## **Demande d'informations additionnelles de la Régie de l'énergie**

**DEMANDE D'INFORMATION ADDITIONNELLE DE LA RÉGIE DE L'ÉNERGIE (LA RÉGIE) À  
HYDRO-QUÉBEC DANS SES FONCTIONS DE COORDONNATEUR DE LA FIABILITÉ AU QUÉBEC (LE  
COORDONNATEUR) - DEMANDE D'ADOPTION DE LA NORME DE FIABILITÉ PRC-006-NPCC-2 –  
DÉLESTAGE EN SOUS-FRÉQUENCE AUTOMATIQUE**

**Norme PRC-006-NPCC-2**

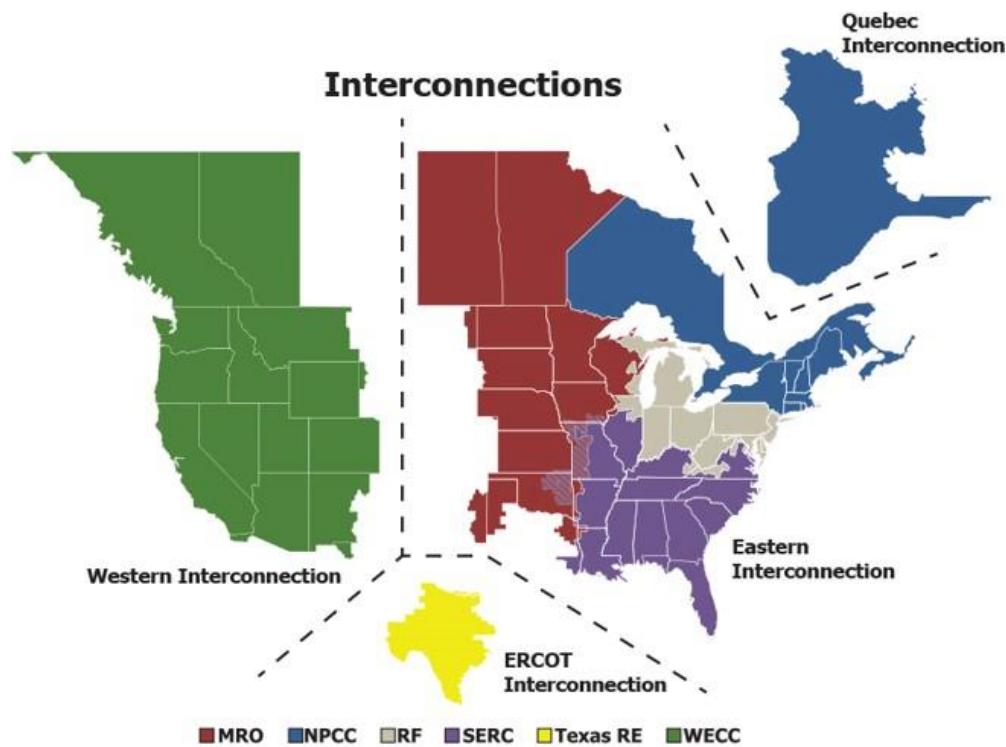
**Dans l'annexe B, l'erreur suivante a été constatée laquelle est soulignée en bleue:**

**« 2.3 Le délestage compensateur assuré par le distributeur ou le propriétaire d'installation de transport s'ajoute à la charge que celui ci doit délester conformément à l'exigence E4 de la présente norme. »**

**Figure 2 PRC-006-NPCC-2**

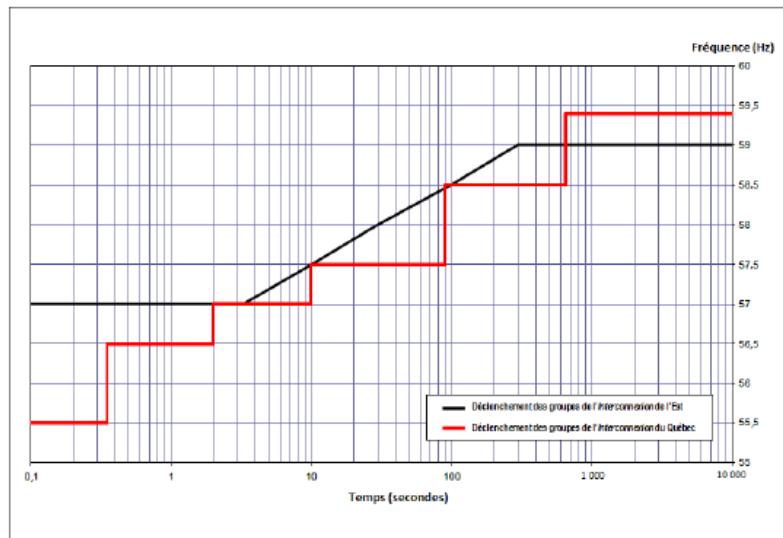
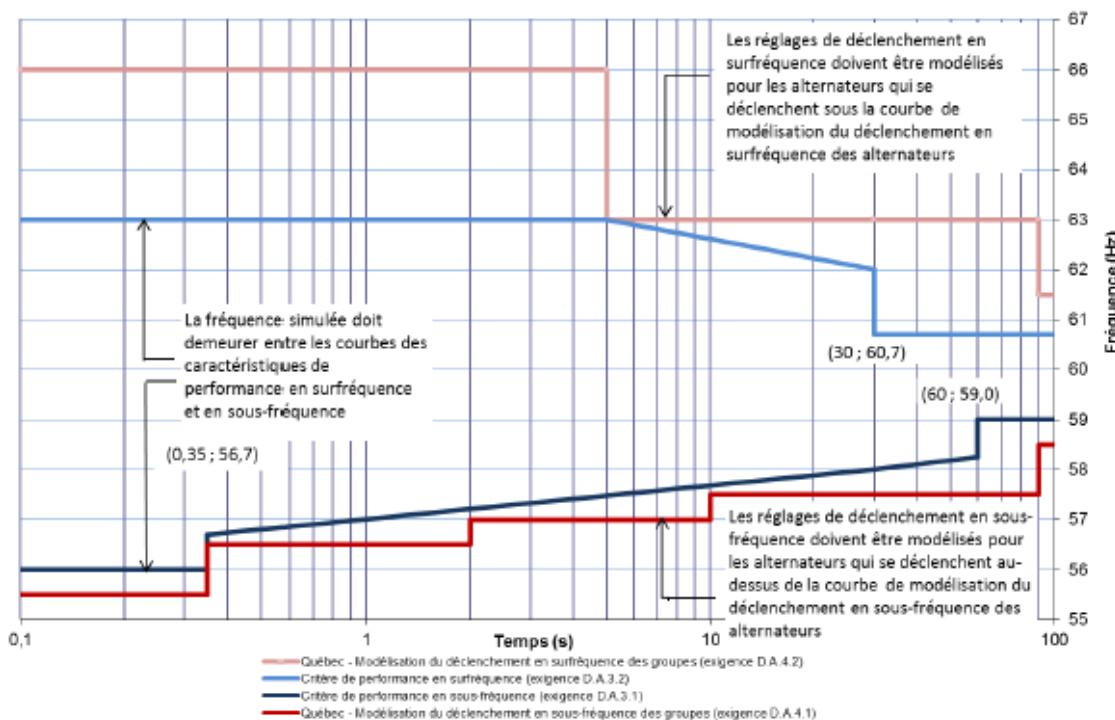
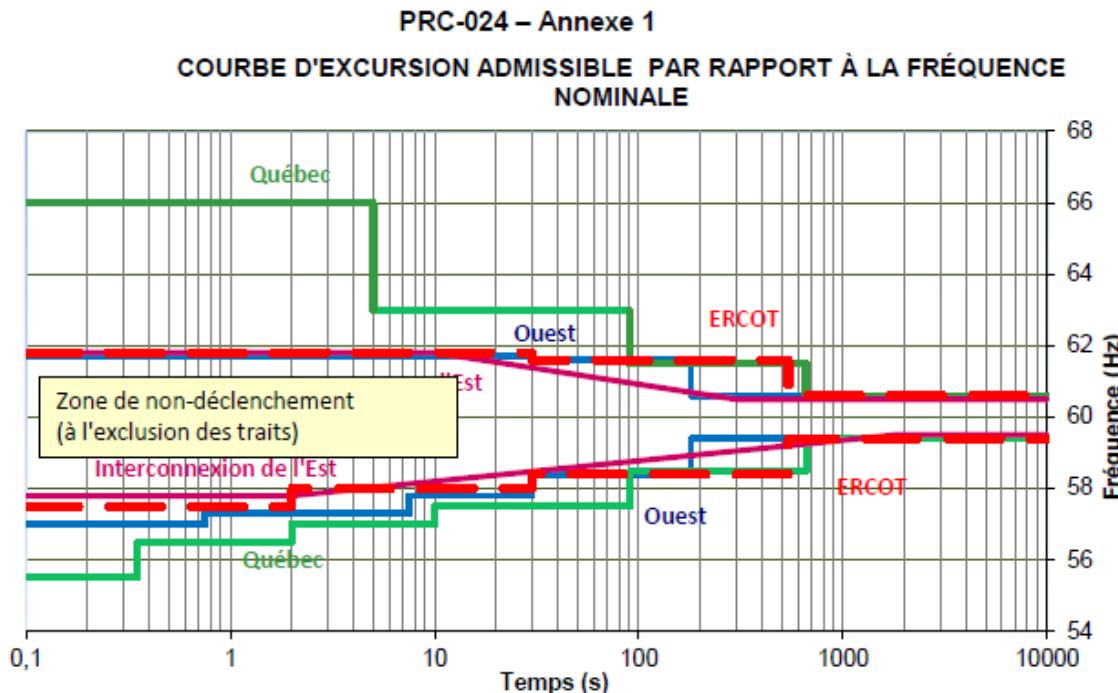
5. Les équations qui permettent de définir la courbe pour l'Interconnexion du Québec (à la figure 2) en s'assurant de faire la différence selon leur source, qu'il s'agisse de la norme PRC-006 de portée continentale ou de celle régionale relative au DSF, au même titre que les données des courbes présentées à la figure 1;

**R5 Le programme de délestage en sous-fréquence est établi comme suit selon la figure 2 de la norme PRC-006-NPCC-2 et l'annexe 1A de l'Annexe Québec de la norme PRC-006-3 pour la courbe de déclenchements groupes production de l'Interconnexion du Québec :**

**Il est important de noter que la courbe de la figure 2 de la norme de fiabilité régionale PRC-006-NPCC-2 est identique à la courbe de l'annexe 1 de la norme PRC-024-1 en vigueur dans l'Interconnexion du Québec.**

**Figure 2**  
**PRC-006-NPCC-2**  
**Underfrequency Load Shedding Program – Thresholds for Setting Underfrequency Trip Protection for Generators**

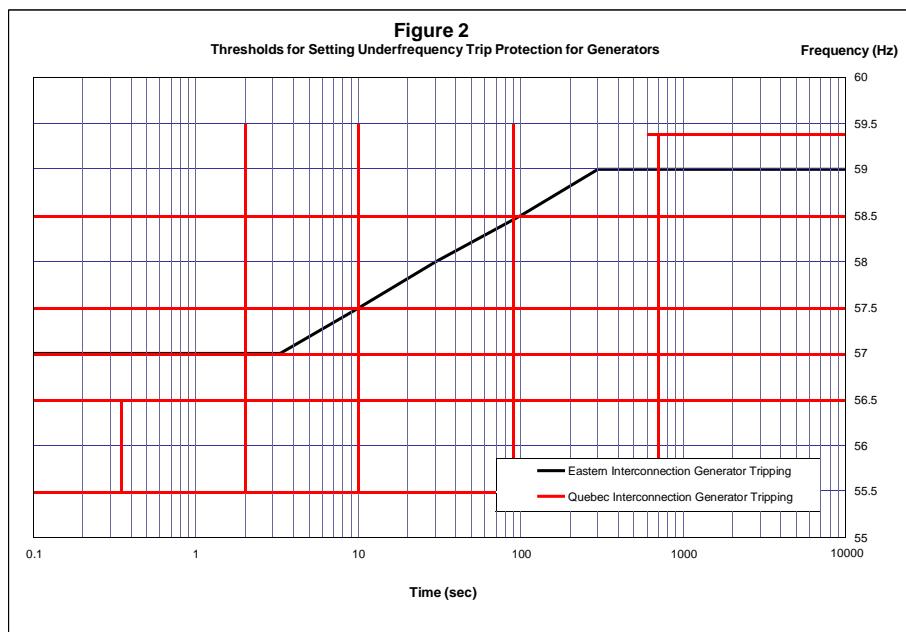
**Commenté [GJ11]:** Please note this annotated Word document was converted from a PDF version. Thus the figures did not correctly follow; the present document should not directly be used in preparing a revised version of the Standard.
